APPENDIX 6

APPLICANT'S RESPONSE TO DEFERRED MATTERS

HEATHCOTE HALL DA17/0467 1-21 Dillwynnia Grove, Heathcote

Response to Record of Deferral

RECORD OF DEFERRAL HISTORIC HEATHCOTE HALL 1-21 Dillwynnia Grove, Heathcote Sutherland

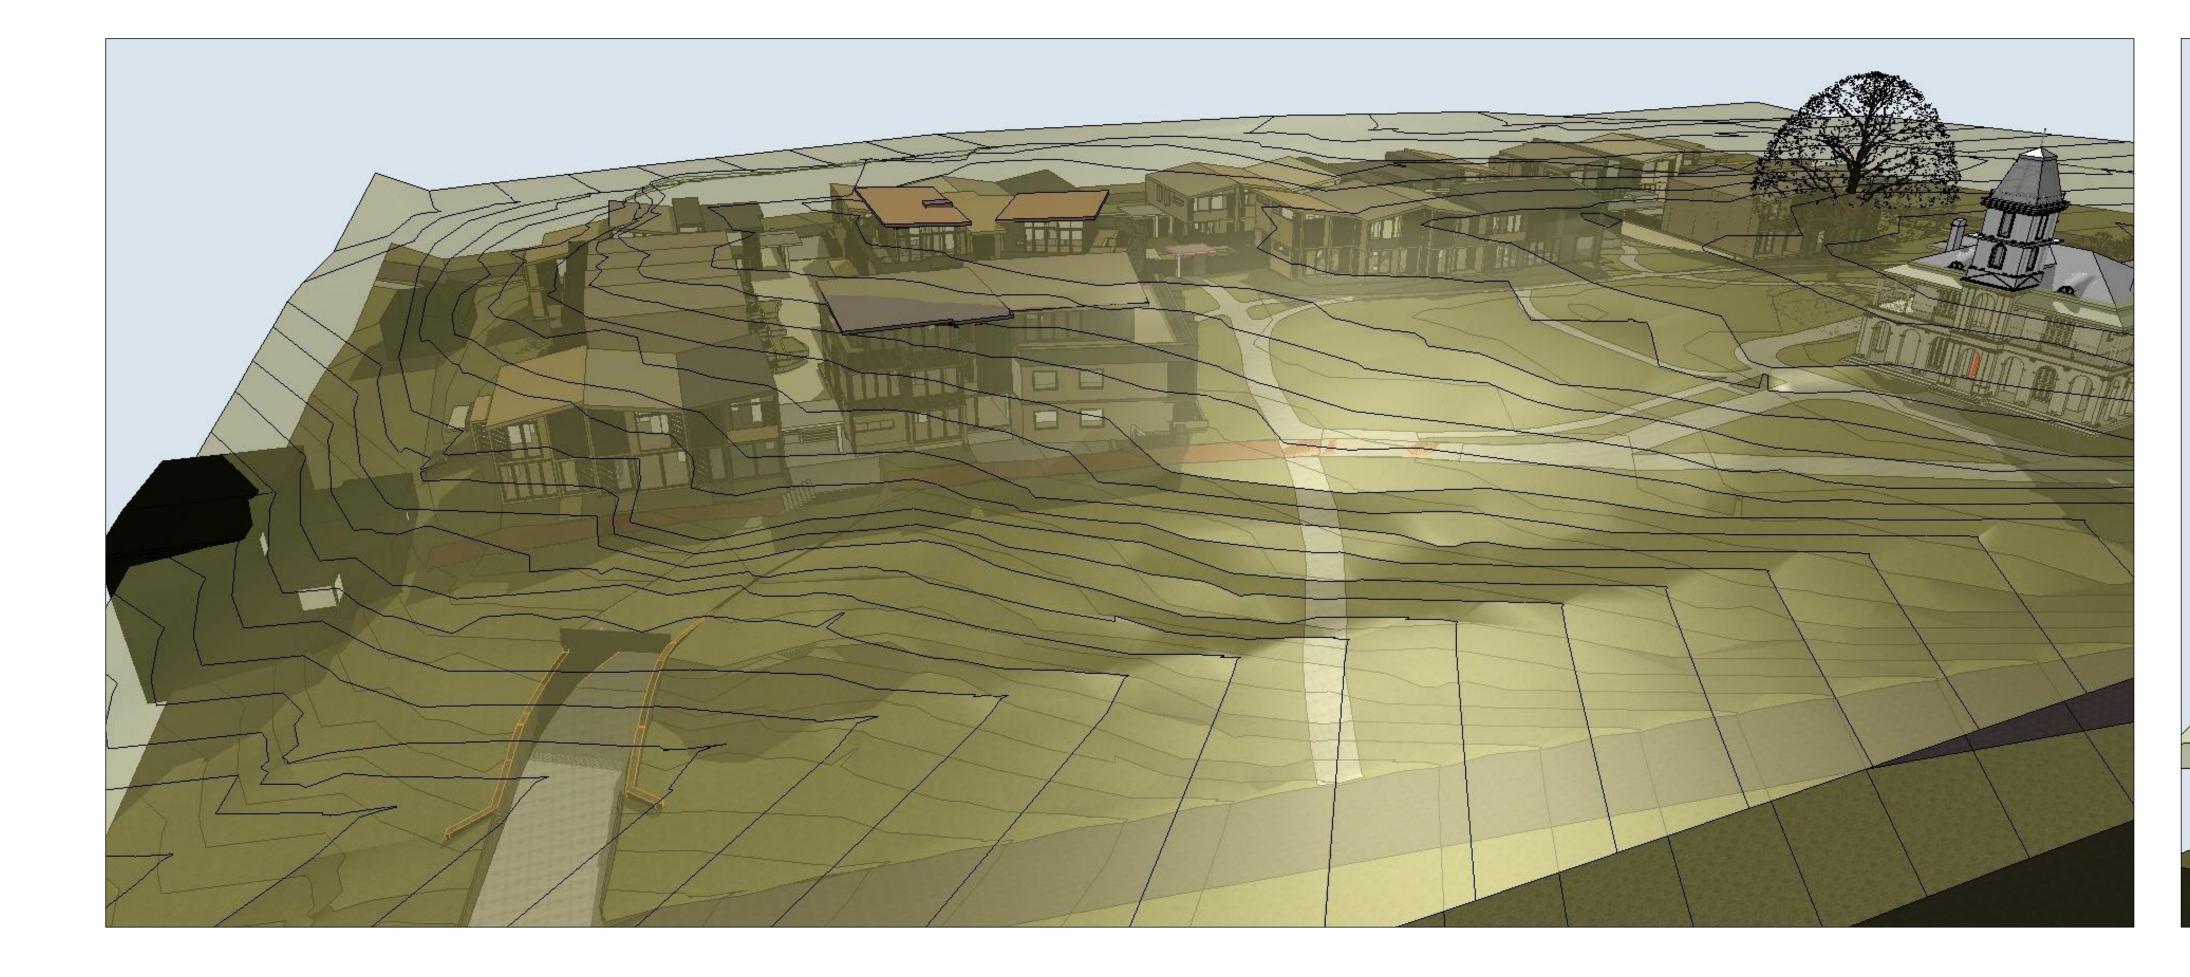
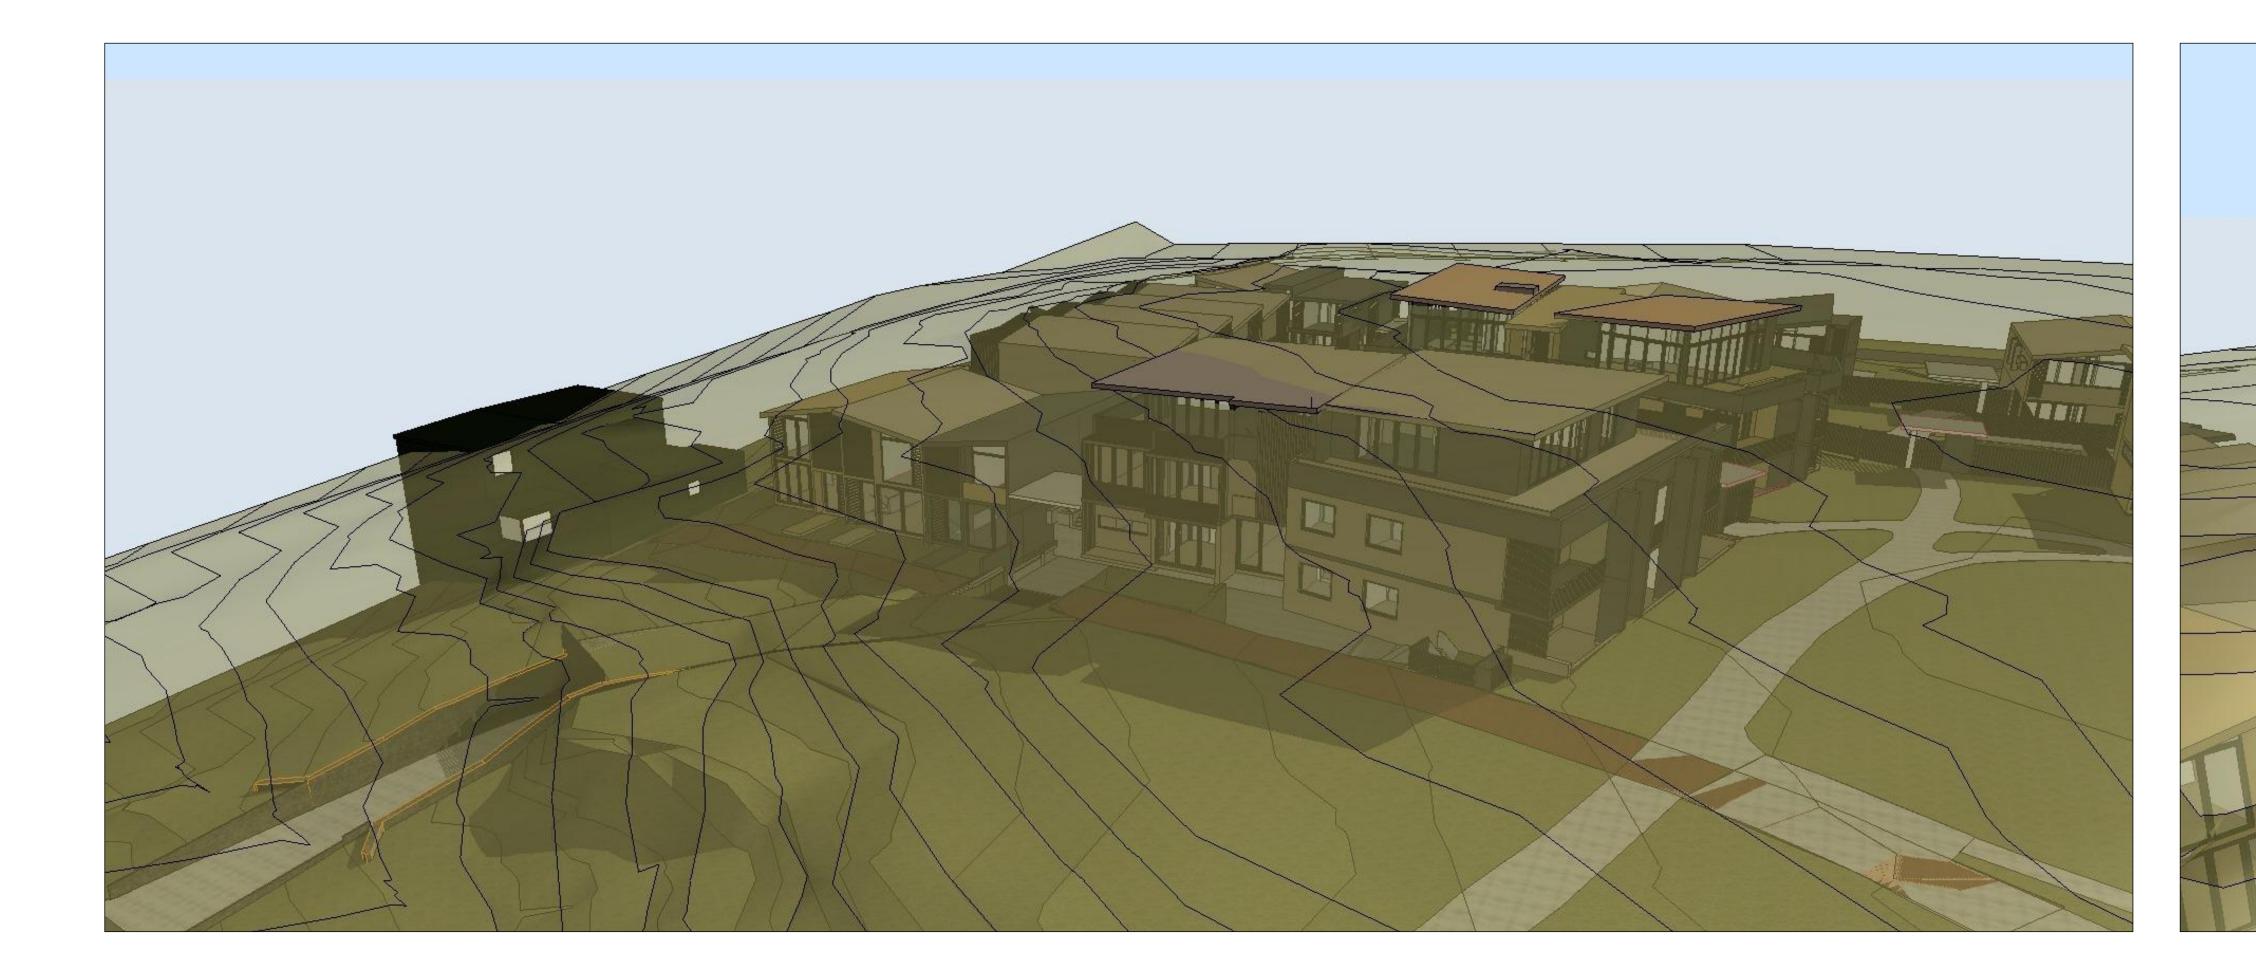
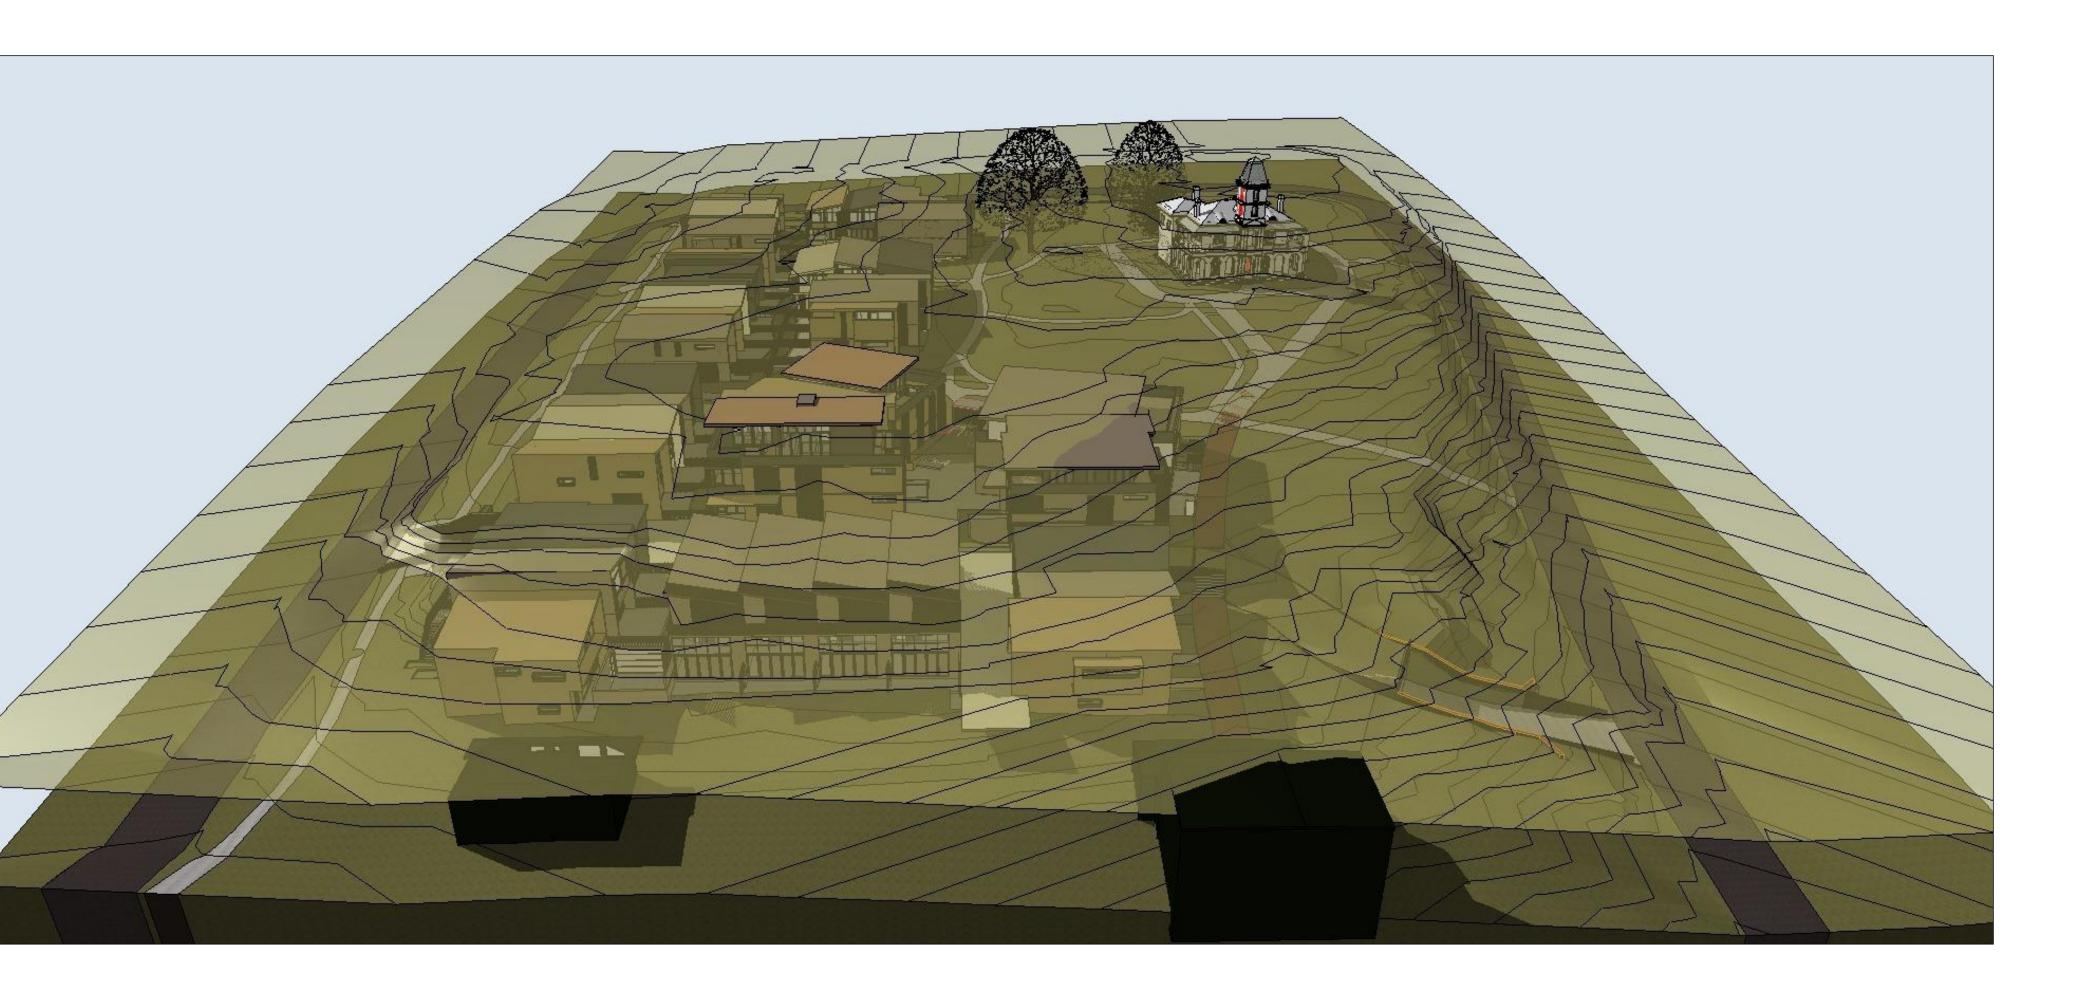
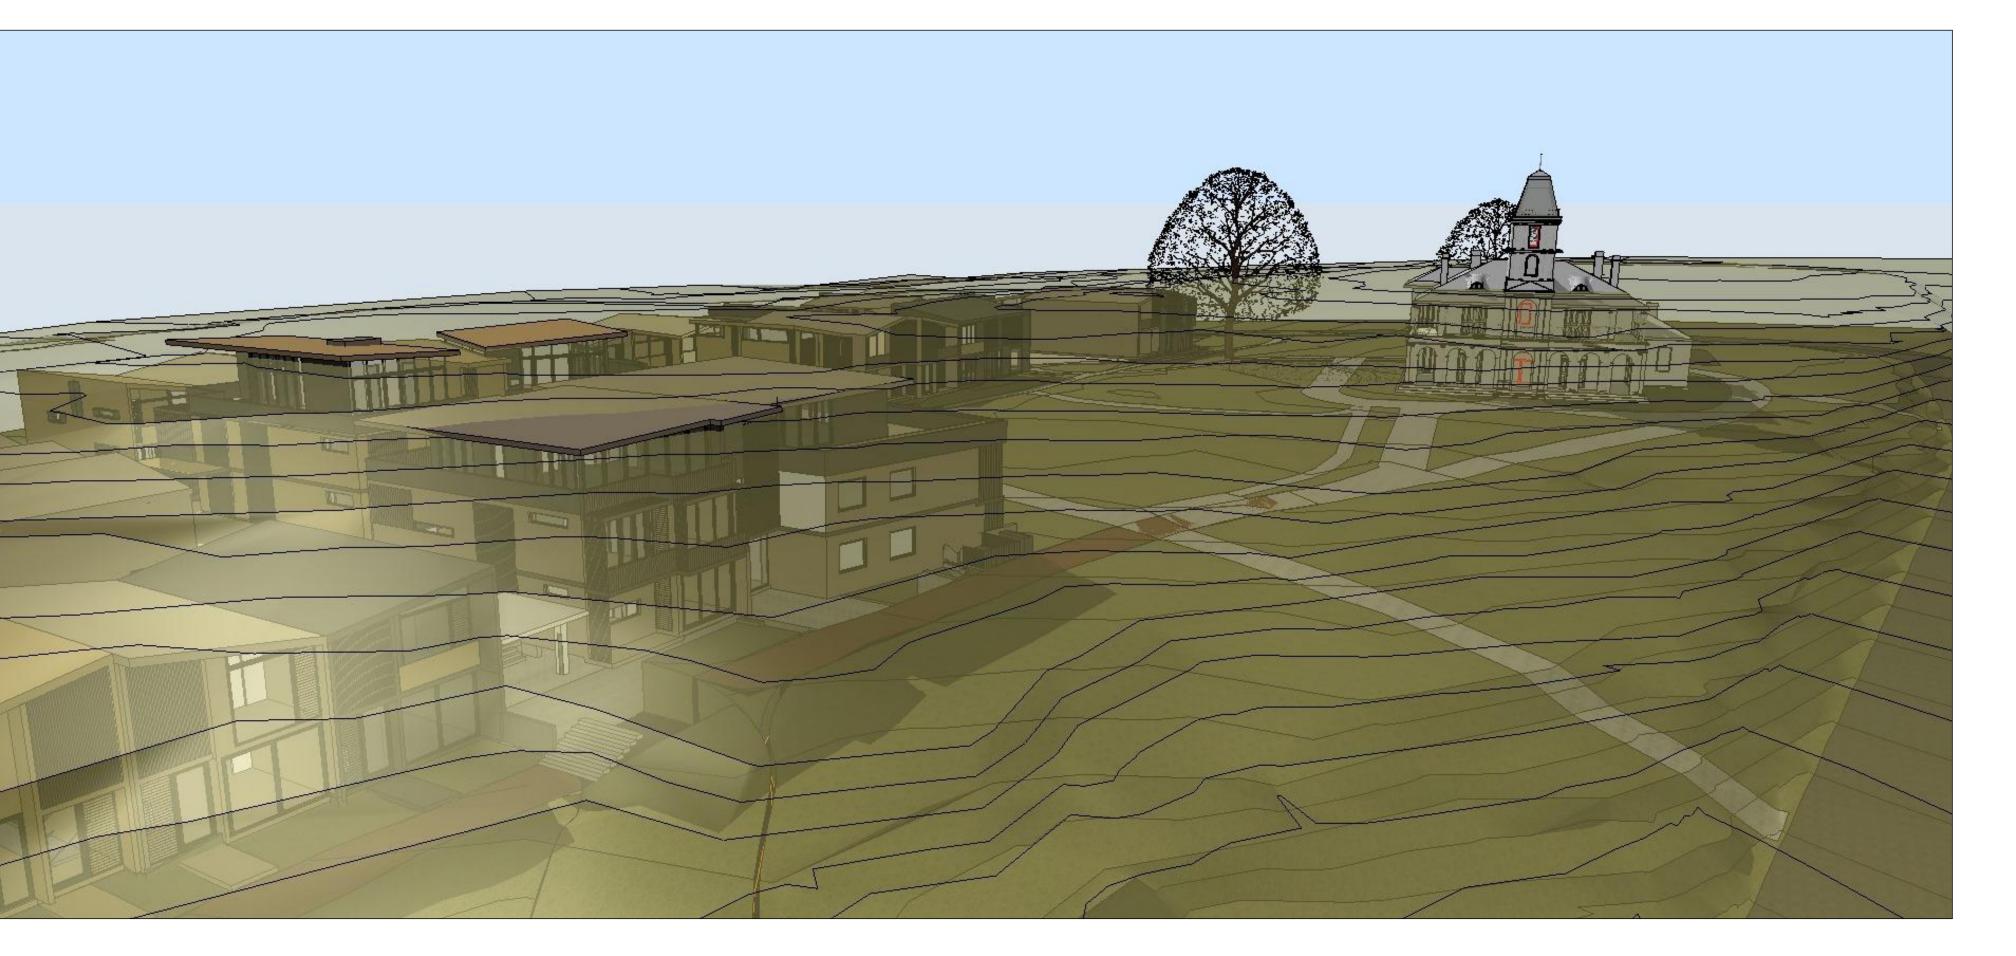
- The height of Building A must be no greater than 9.1m, with a maximum RL of RL221.534 above existing ground level (ground level at the date of issue of the decision), excluding lift overrun.
- ii) The height of Building B must be no greater than 8.5m, with a maximum RL of RL221.076 in height above existing ground level (ground level at the date of issue of the decision), excluding lift overrun.
- iii) The height of Townhouses 30 and 31 must be no greater than 8.5m in height above existing ground level (ground level at the date of issue of the decision). The maximum RL of Townhouse 30 must be RL217.759 and the maximum RL of Townhouse 31 must be RL217.731.

- The height of Building A has been reduced to be no greater than 9.1 m as requested, with a maximum RL 221.235, below the maximum permissible of RL 221.534 (refer to Drawing DA-12 Section J-J)
- ii) The top most level of Building B has two apartments. Apartment B 22 which is compliant with 8.5 m maximum height and maximum RL of 220.852, below the maximum permissible RL of 221.076. Apartment B 21 is slightly over the maximum 8.5 height control plane due to the sloping terrain but is compliant with the maximum permissible RL of 221.076 showing a maximum RL of 220. 633 (please refer to drawing DA-10 Height Plane)

Total roof area of Building B is 381 m². The portion of the roof that breaks the 8.5 m height plane is 88 m², equivalent to 23 % of the roof area.
